22 FRIARS DRIVE ADDITION

STAFF REPORT #2

Map 298, Lot 4, Site Plan, Proposed Building Additions, 22 Friars Drive, Hudson, New Hampshire; prepared by Hayner/Swanson, Inc., 3 Congress Street, Nashua, NH 03062 and 131 Middlesex Turnpike, Burlington, MA 01803; prepared for Integra Biosciences Corp., 2 Wentworth Drive, Hudson, New Hampshire 03051; consisting of 15 sheets plus a cover sheet, with Notes 1-26 on Sheet 1; dated January 27, 2022 and revised March 8, 2022.

Re: Town of Hudson Planning Board Review
22 Friars Drive Site Plan, 22 Friars Drive
Tax Map 209 Lot 4; Acct. #1350-993
Reference No. 20030249.2130

RIPRAP DETAIL AT HEADWALL/OUTLET DETAIL
NOT TO SCALE

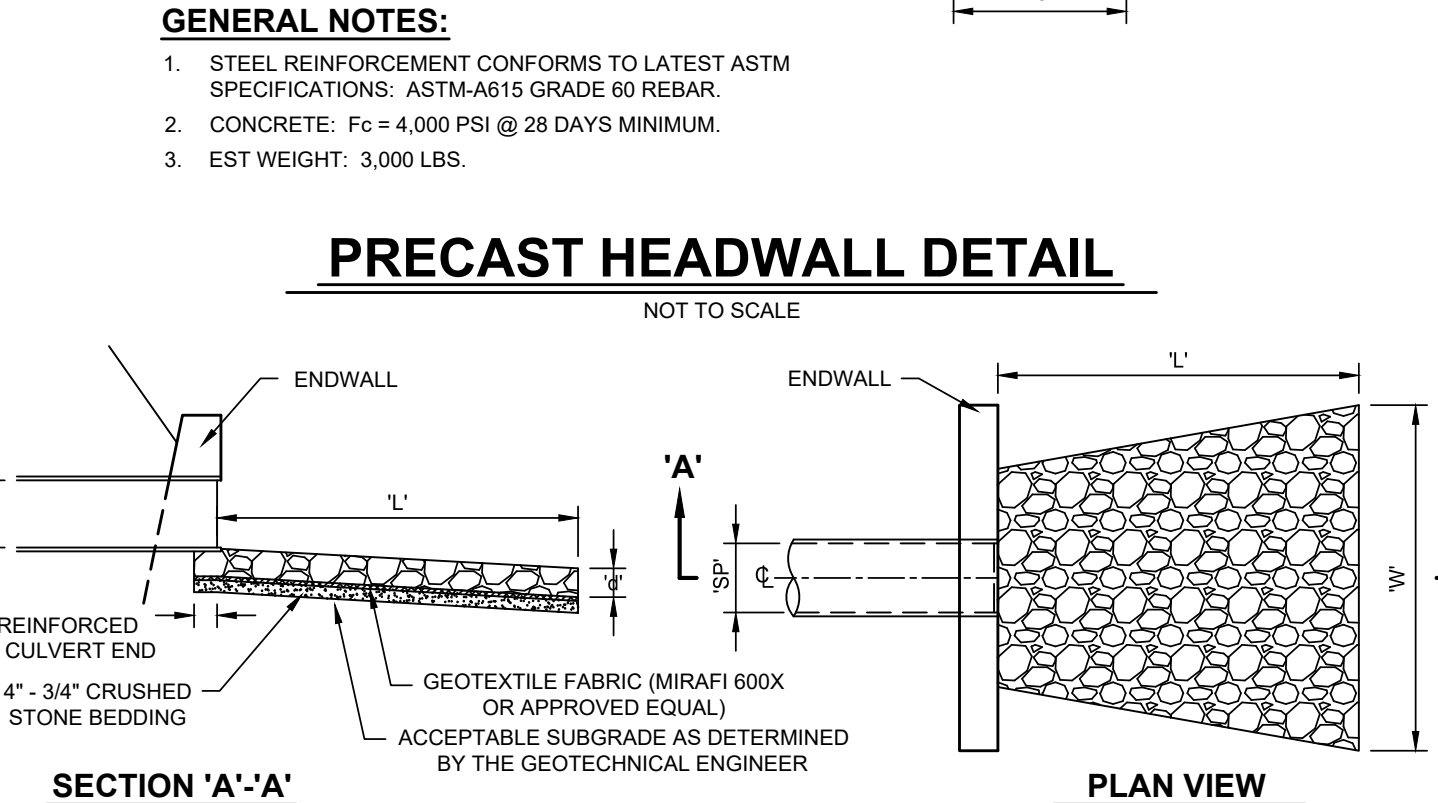
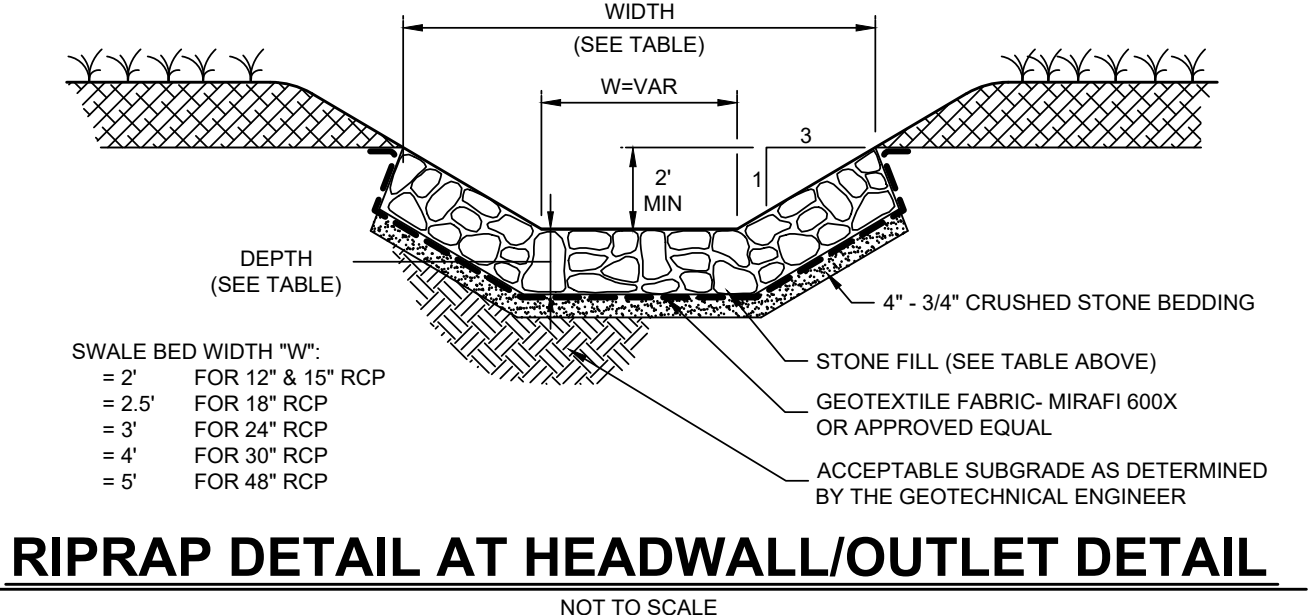
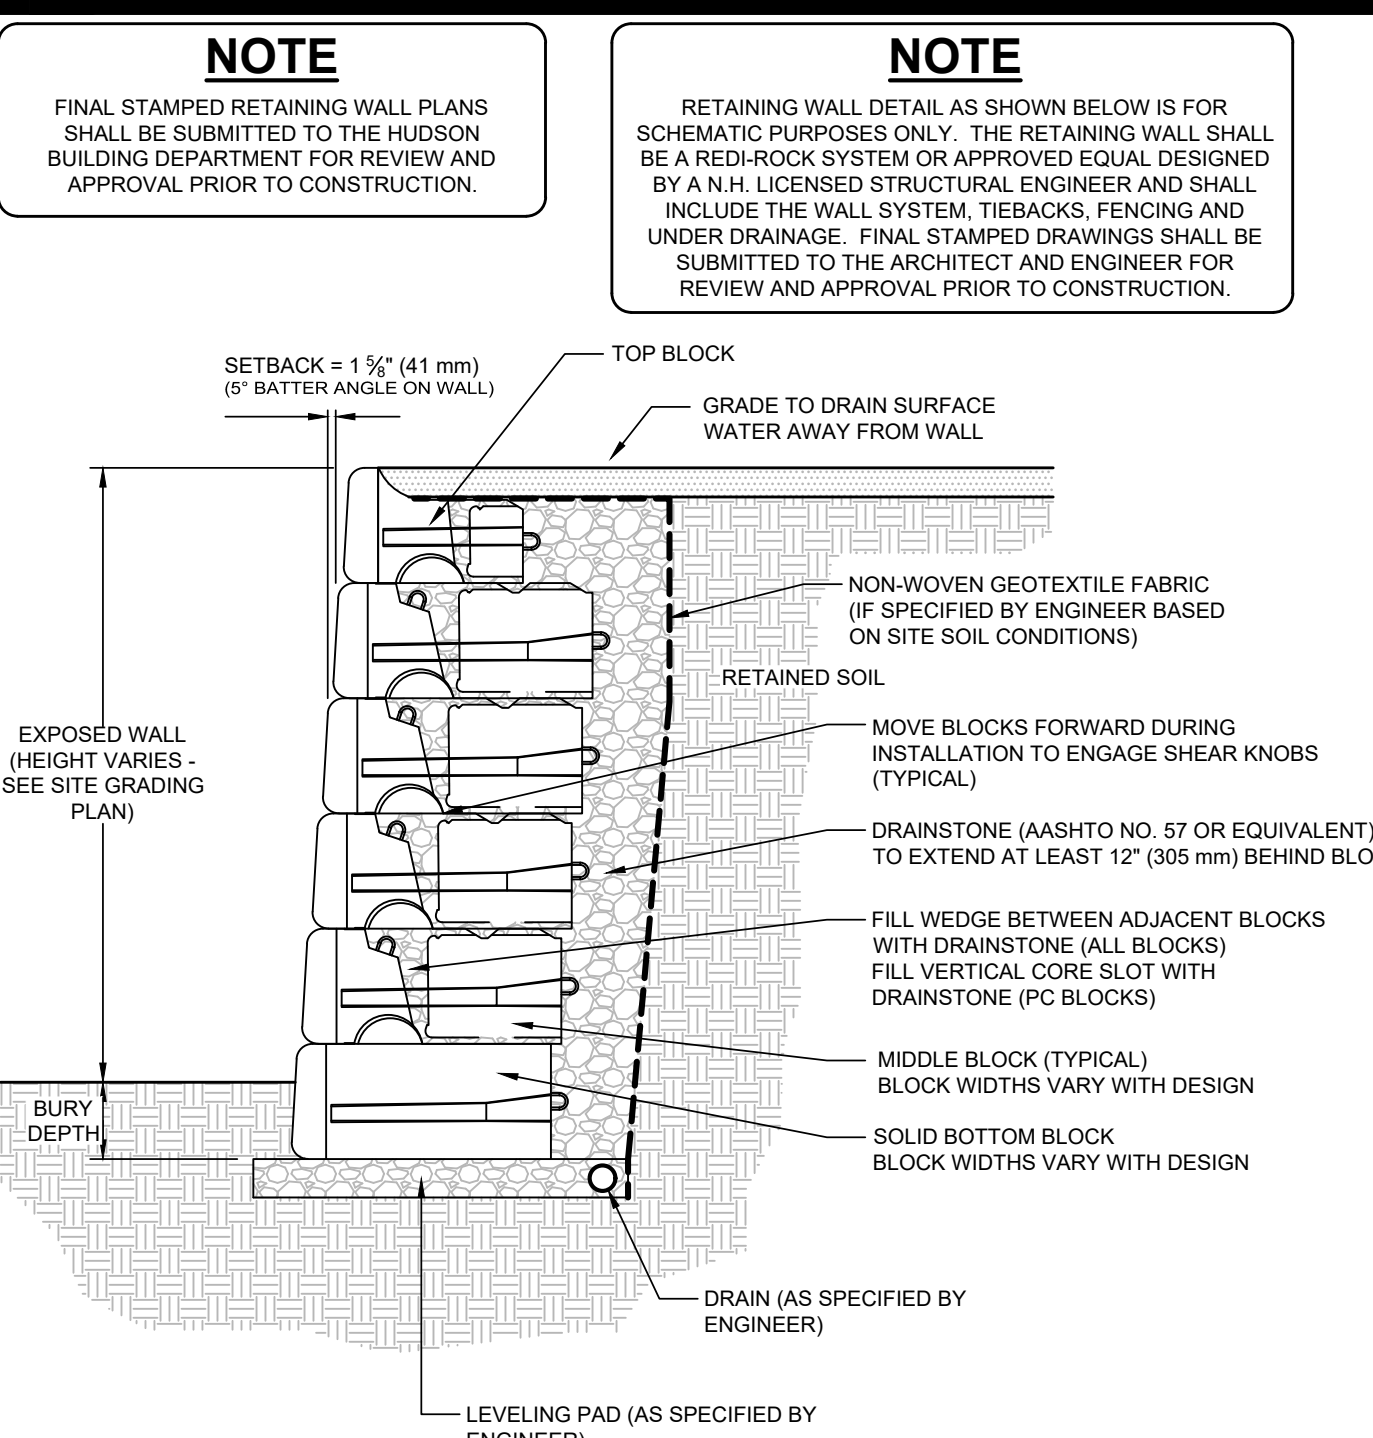
- q. Engineering Technical Guideline & Typical Details (ETGTD) 920.3.1. The applicant should coordinate the outlet protection calculations provided within Appendix E of the AoT permit with the rip rap outlet detail provided upon Sheet 10 of 15.

- q. Engineering Technical Guideline & Typical Details (ETGTD) 920.3.1. The applicant should coordinate the outlet protection calculations provided within Appendix E of the AoT permit with the rip rap outlet detail provided upon Sheet 10 of 15. **The outlet protection calculations demonstrate minimum requirements needed to reduce velocities and protect downstream waterbodies. The dimensions shown in**

the detail on Sheet 10 of 15 are larger than the calculated minimum requirements and therefore meet outlet protection standards.
